Proposal for Amendments to GRE/2023/27

The text reproduced below was prepared by the experts from IWG on EMC, with the aim to develop a new 07 series of amendments to UN Regulation No.10. The proposed modifications to the current text of the UN Regulation are marked in bold for new or strikethrough for deleted characters.

Figure 4 Example of a selection of antenna placements for lateral illumination of a large vehicle

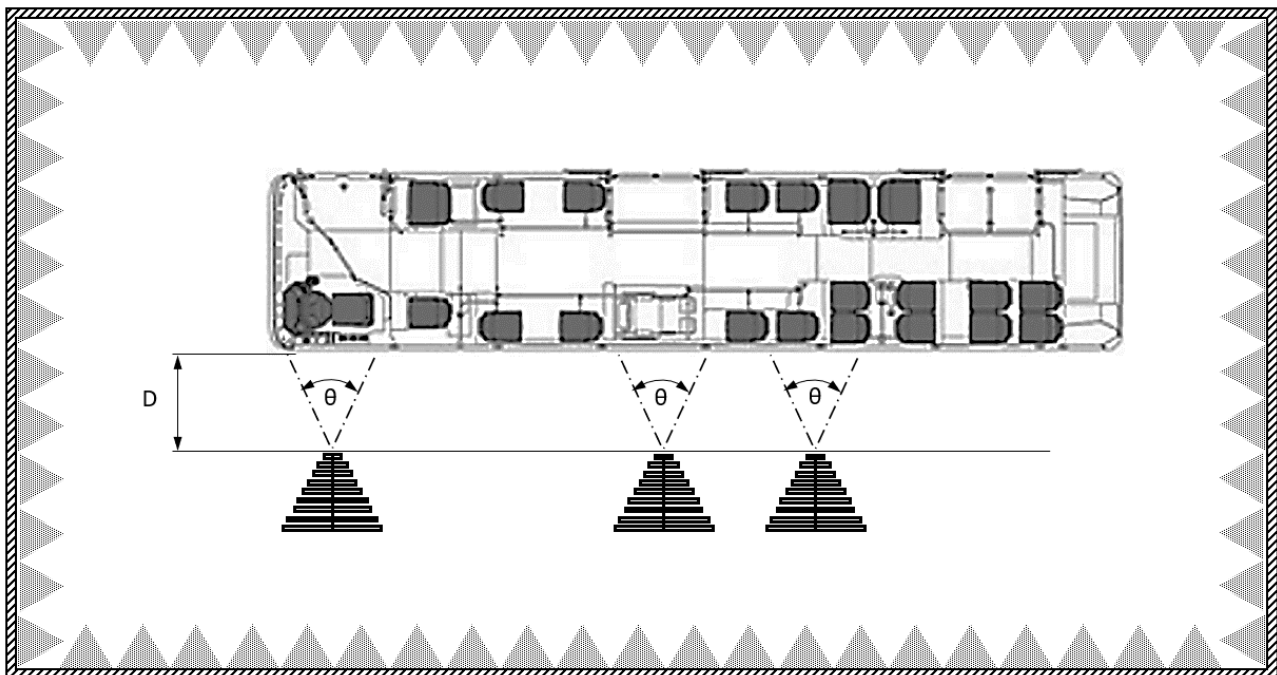
Annex 6, Appendix 1, amend to read:

Figure 1
Charging mode configuration for Annex 16"

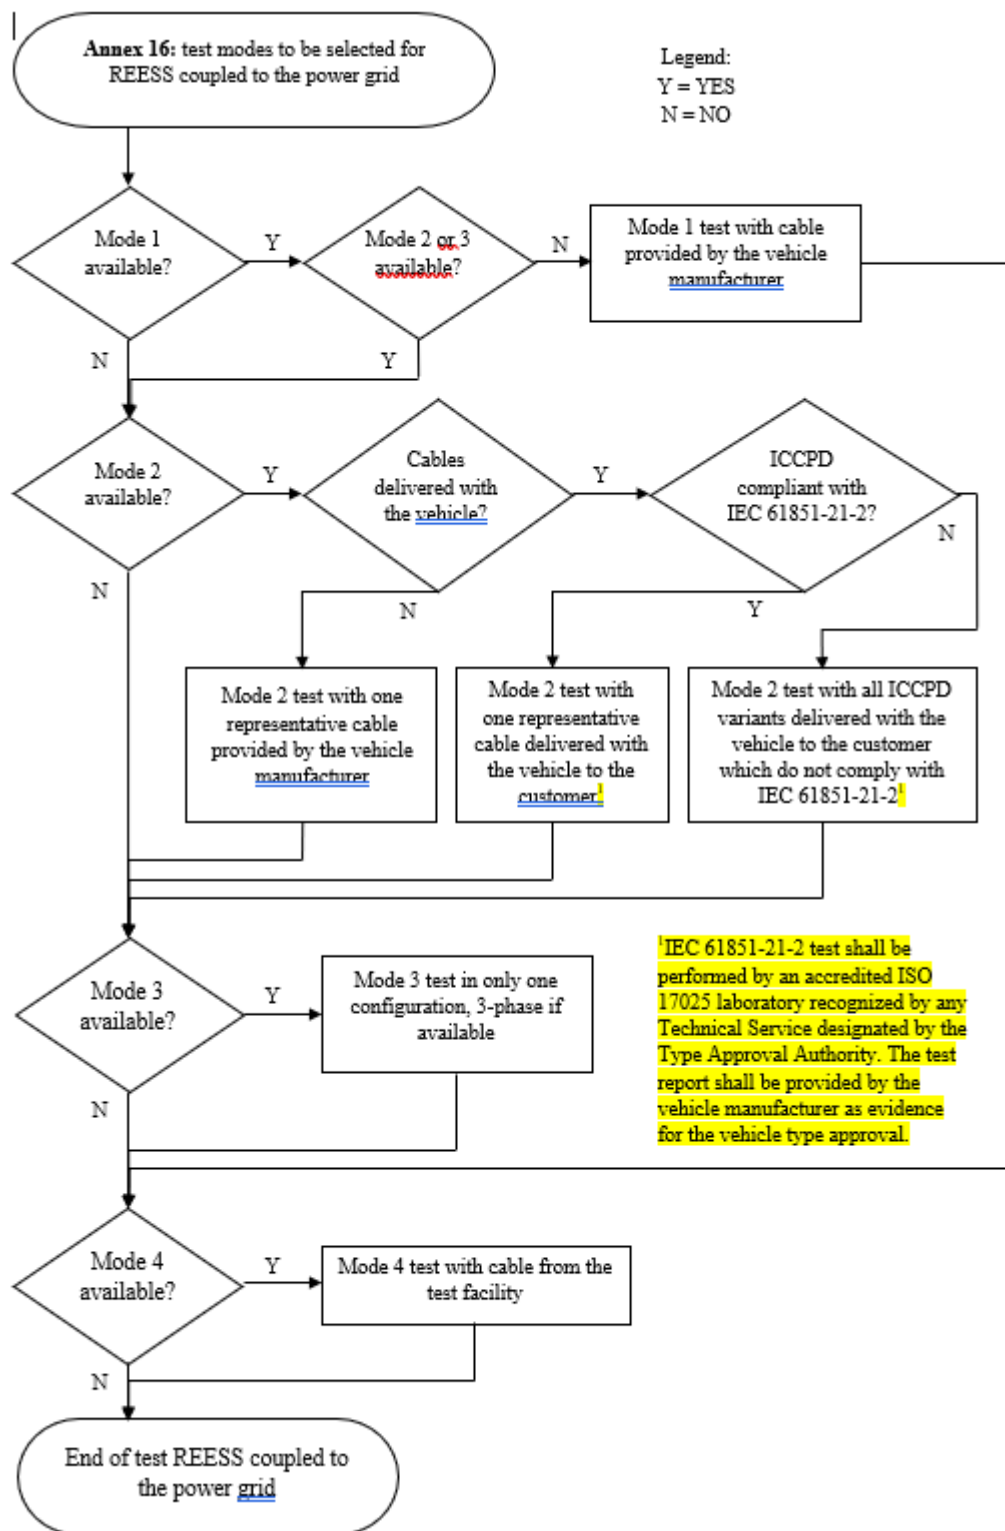
The vehicle shall be tested in the charging mode configuration (if available on vehicle) as defined in flowchart of figure 1
